CITY OF CODY
PLANNING, ZONING AND ADJUSTMENT BOARD
TUESDAY JULY 12, 2022
CITY HALL COUNCIL CHAMBERS @ 12:00 NOON

MEETING DATE:	JULY 12, 2022	TYPE OF ACTION NEEDED	
AGENDA ITEM:		P&Z BOARD APPROVAL:	
SUBJECT:	PRELIMINARY PLAT OF THE SUNRIDGE SUBDIVISION— A 5-LOT SUBDIVISION. SUB 2022-04	RECOMMENDATION TO COUNCIL:	X
PREPARED BY:	TODD STOWELL, CITY PLANNER	DISCUSSION ONLY:

PROJECT: **SUNRIDGE MINOR SUBDIVISION**
TITLE: **TITLE SHEET**

PROJECT: SUNRIDGE MINOR SUBDIVISION
TITLE: PLAN & PROFILE – ROADWAY

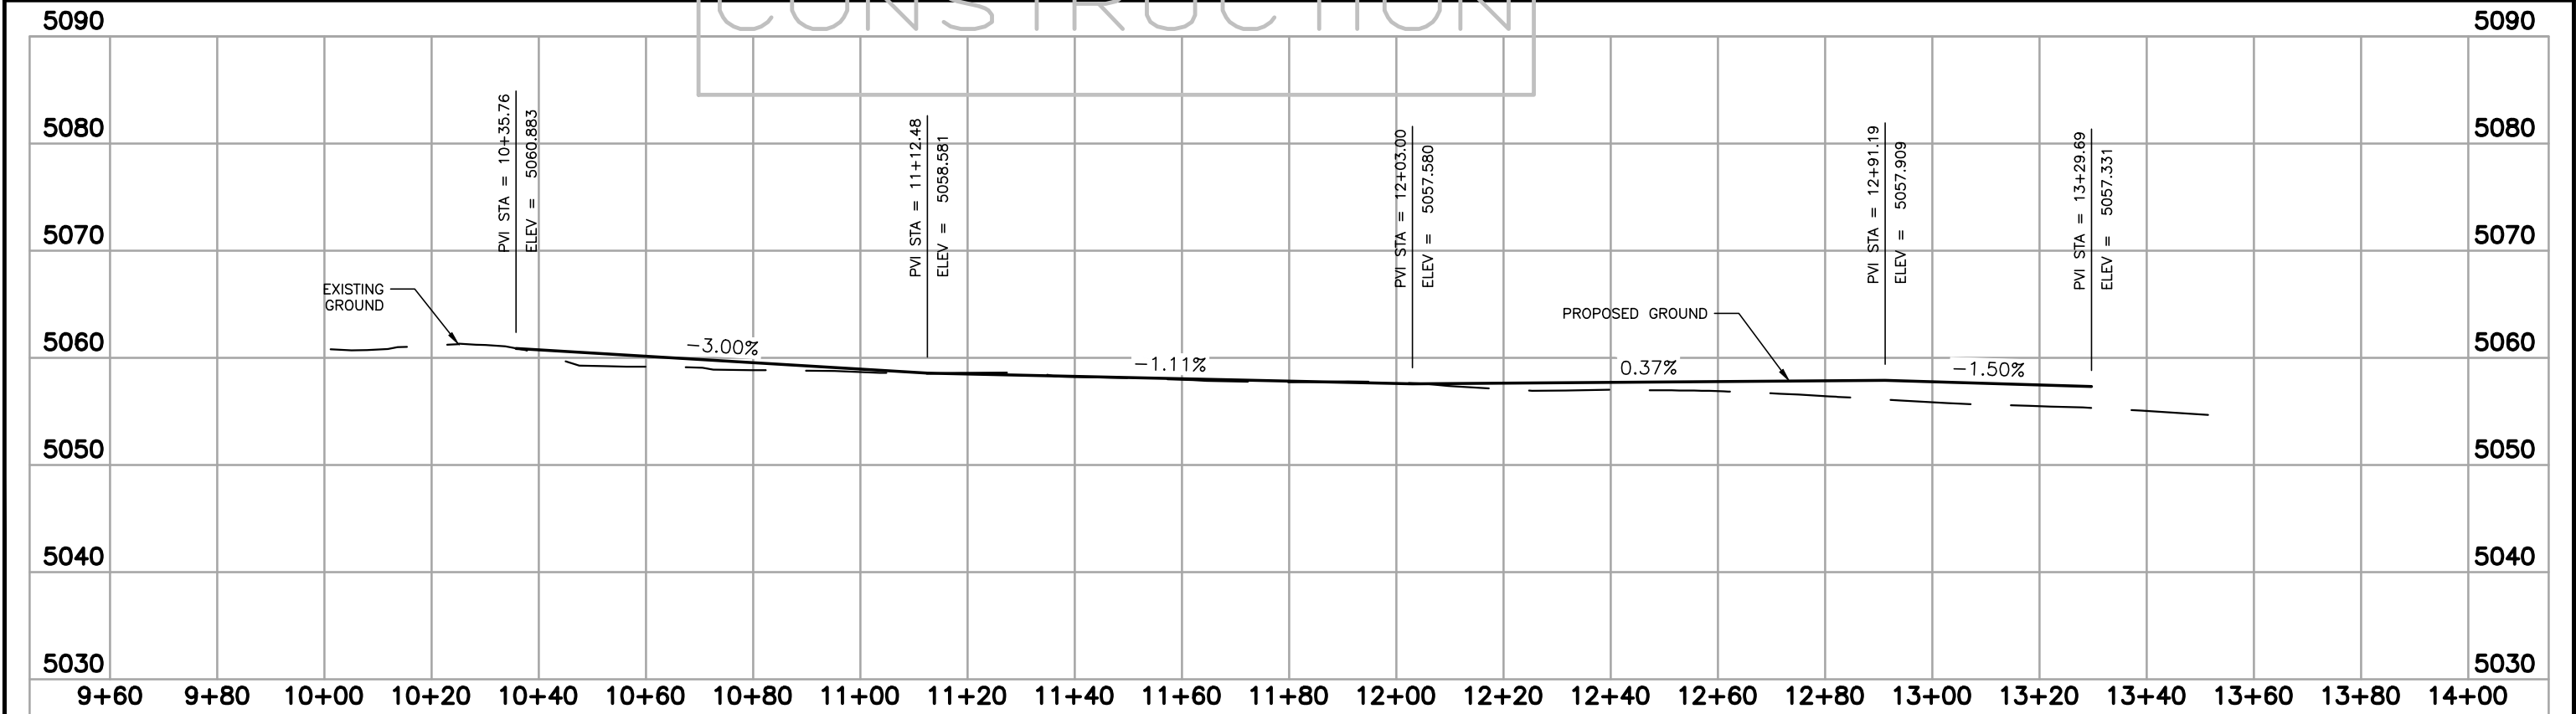
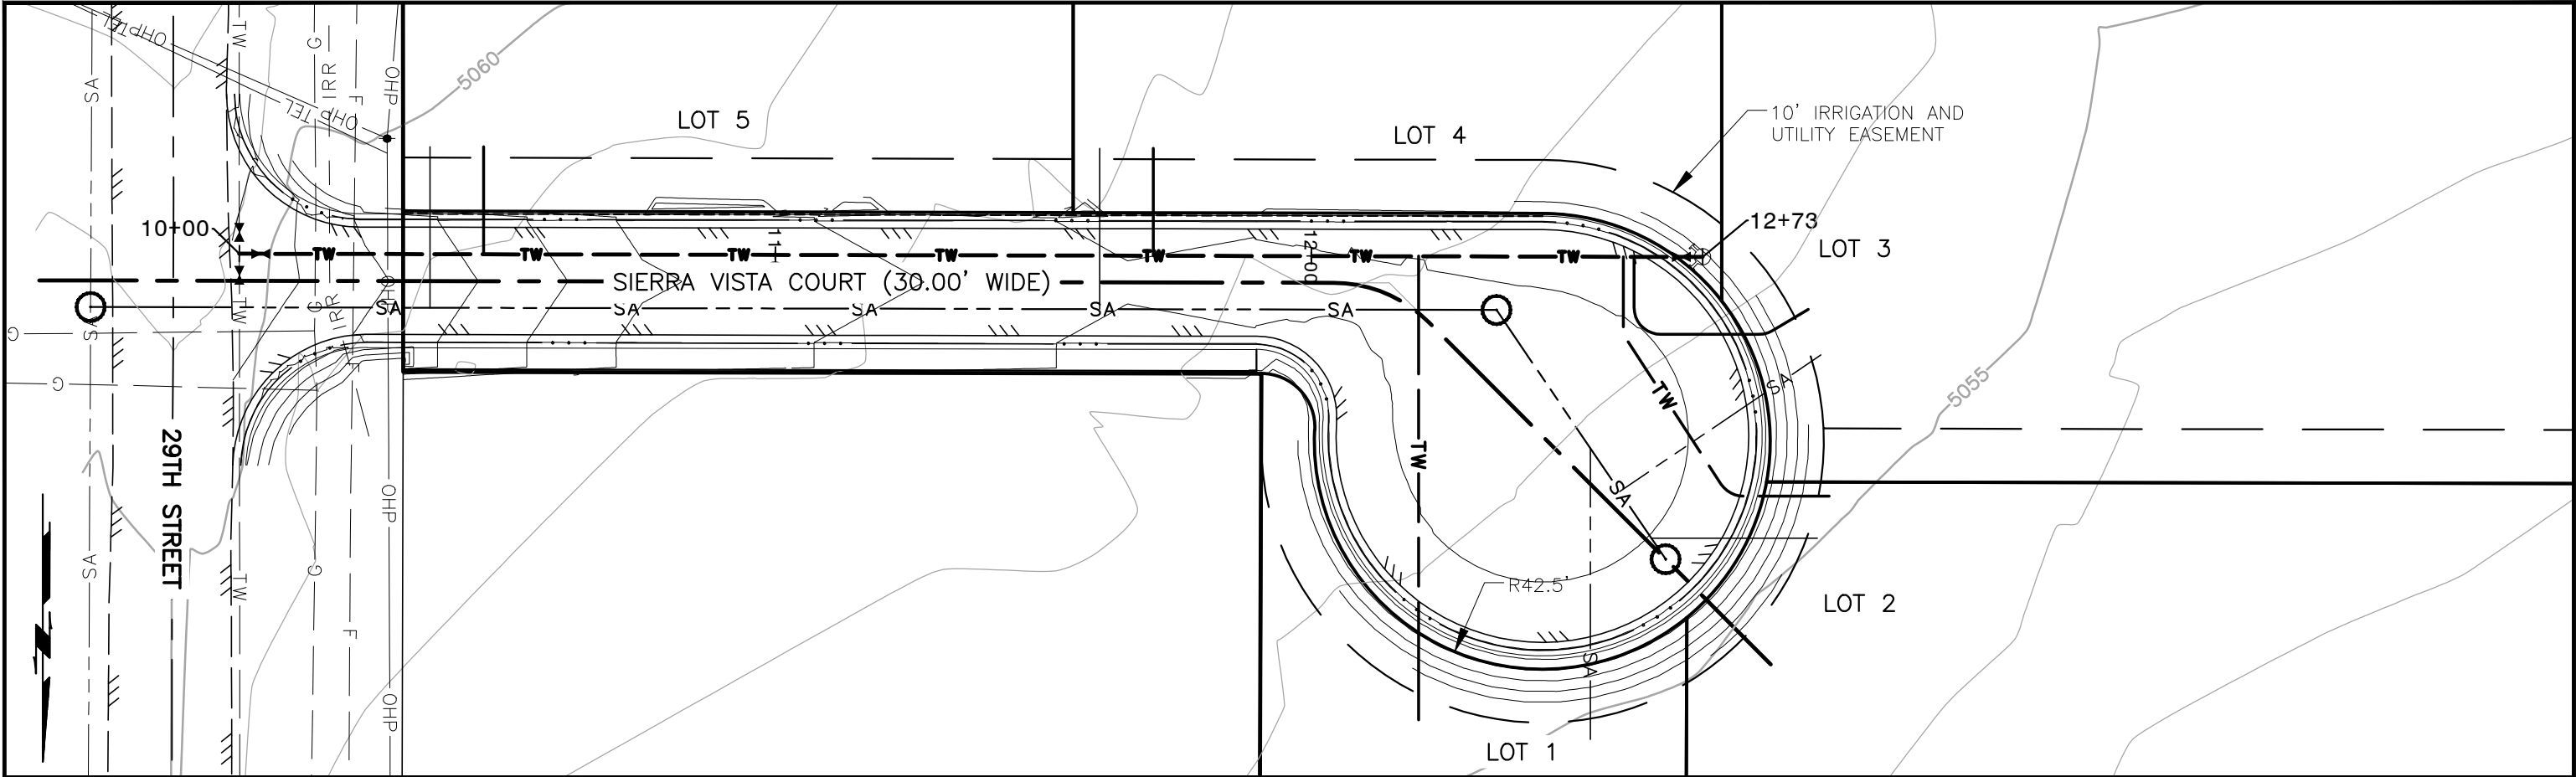
Comment: The street location seems to be the most logical. Details regarding the profile of the street centerline can be seen in the draft construction plans and likely need modification to better address street drainage and adequate cover for the sewer services. Those details can be discussed between the engineer and public works before final plat review.

Comment: The plans appear to show the curb of the new street extending to the edge of 29th Street, with a 25-foot radius. The radius is appropriate for the conditions. However, due to the planned pathway along 29th Street and the lack of curb and gutter on 29th Street, the curb and gutter can end at the edge of the 29th Street right-of-way, with a taper in the curb height.

Comment: Not yet identified on the plans. A street name sign will be needed, as well as a stop sign, "No Outlet" sign, and no parking signs. The sign plan should be incorporated into the construction plans.

PROJECT: **SUNRIDGE MINOR SUBDIVISION**
TITLE: **PLAN & PROFILE – SANITARY SEWER**

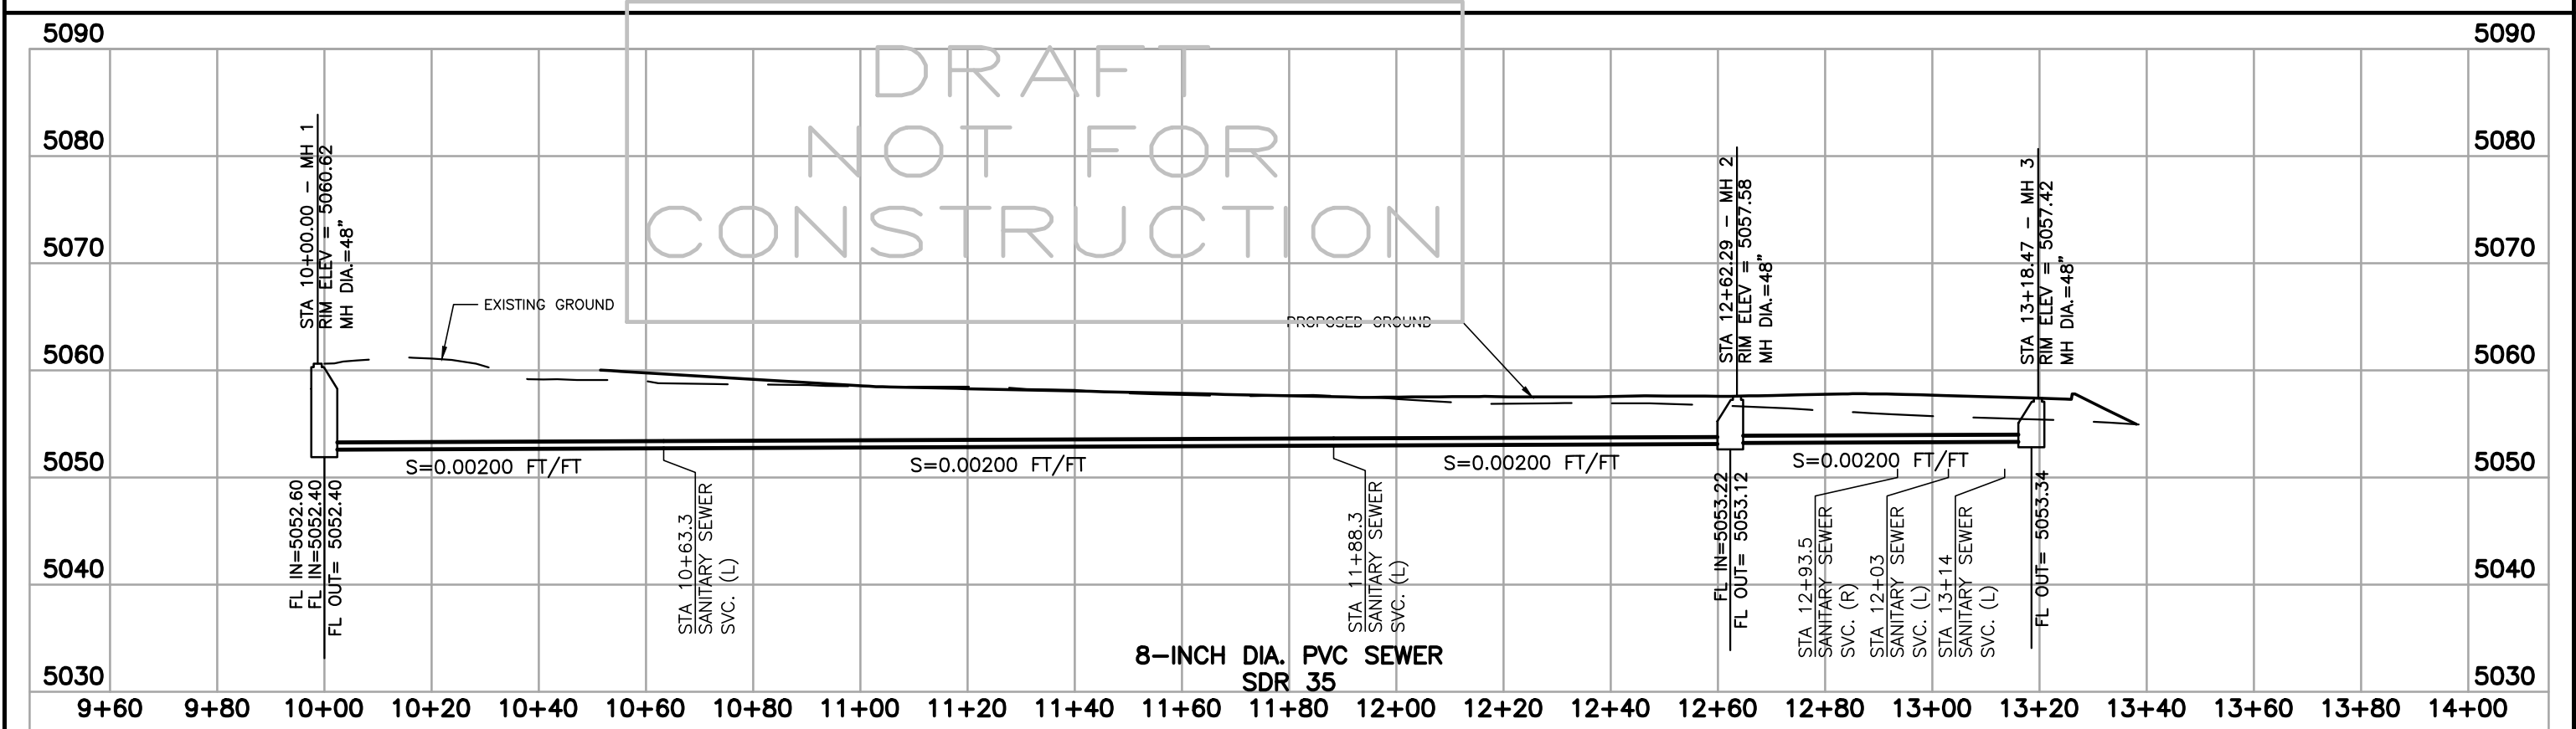
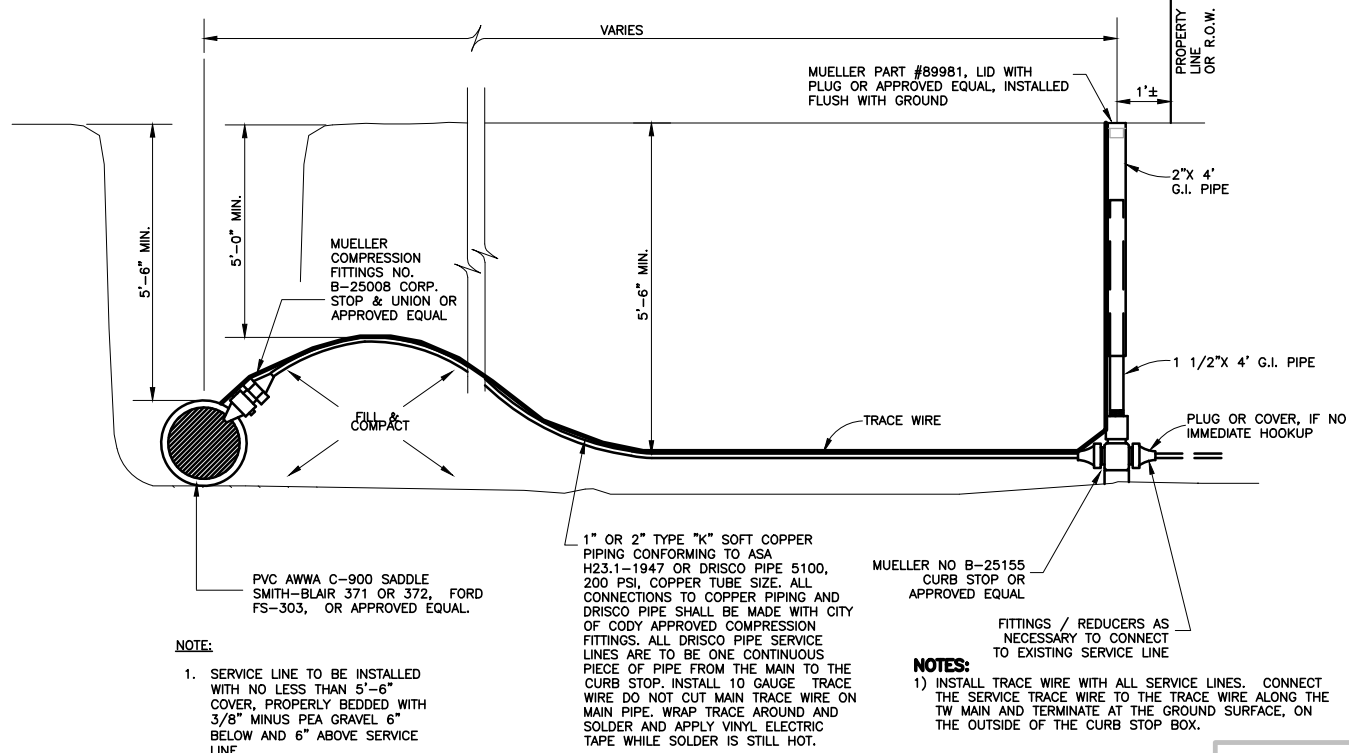
Comment: Sanitary sewer is proposed to be extended into the subdivision. There is concern that the sewer services coming off of the main are too shallow and therefore subject to freezing. Frost depth in Cody is considered 48 inches (4 feet) and the sewer services for Lots 1 and 3 would be somewhere in the range of two to two-and-a-half feet of cover at the curb. Lot 2 would have slightly more and Lots 4 and 5 should be fine. Options include adjusting the street elevation and/or going with low-pressure lines which are not dependent on gravity flow. Additional work is needed on this issue.
